Response to Woodland Trust comments, dated 20th April 2022

Land north of Long Copse Lane, Emsworth, ref:
APP/21/00893

11th May 2022

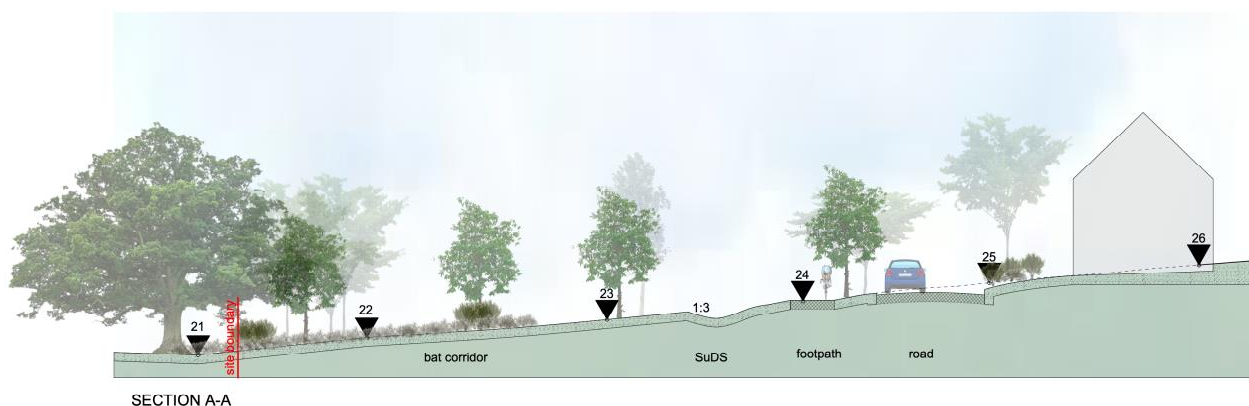
16. The extent of buffer zones associated with the application has been subject to very significant discussion with Natural England and HCC Ecology, taking into account 'Trowbridge guidance' regarding minimum depths and lighting. The proposals succeed in the wider objective of providing dark zones for bats, including Bechstein's bats, whilst also leaving substantial distance to the area of ancient woodland on the northern boundary.
17. It should be noted that the land falls away from the middle of the site to the north, meaning that the ancient woodland area is sat significantly below the areas of development. This is as identified in the cross-section overleaf.

18. The landscape buffer also varies in depth with 30m forming the minimum, this being taken from section A-A on the cross-sectional plan. For much of the northern boundary where the ancient woodland is located, the buffer measures between 35m and 50m.
